RA12-003c

2013 JX35, 2014-2015 QX60/QX60 HYBRID; VIBRATION AND/OR NOISE WHEN MAKING LOW SPEED TURNS

This bulletin has been amended to add Applied Vehicles and to remove the Service Procedure that is now available in the Electronic Service Manual. Please discard previous versions.

Figure 1

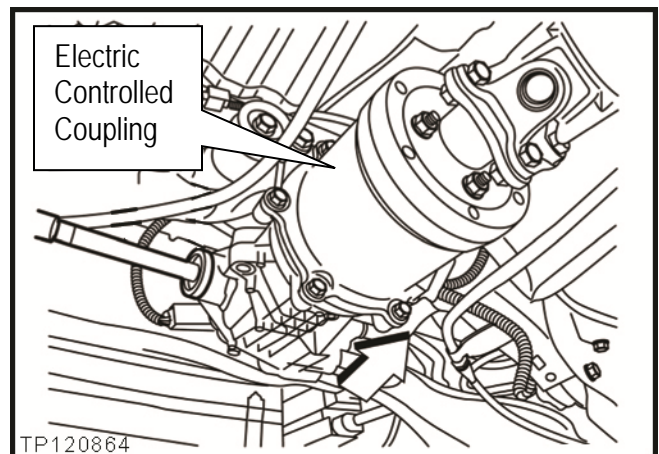
Replace the Electric Controlled Coupling for the rear final drive.

- **DO NOT** replace the entire Rear Final Drive assembly for this incident, if it should occur.
- **DO NOT** remove the Rear Final Drive assembly for this procedure. The Electric Controlled Coupling can be replaced with the Rear Final Drive in the vehicle.
- Refer to the Electronic Service Manual (ESM), section **DLN – Driveline**, for removal and installation.
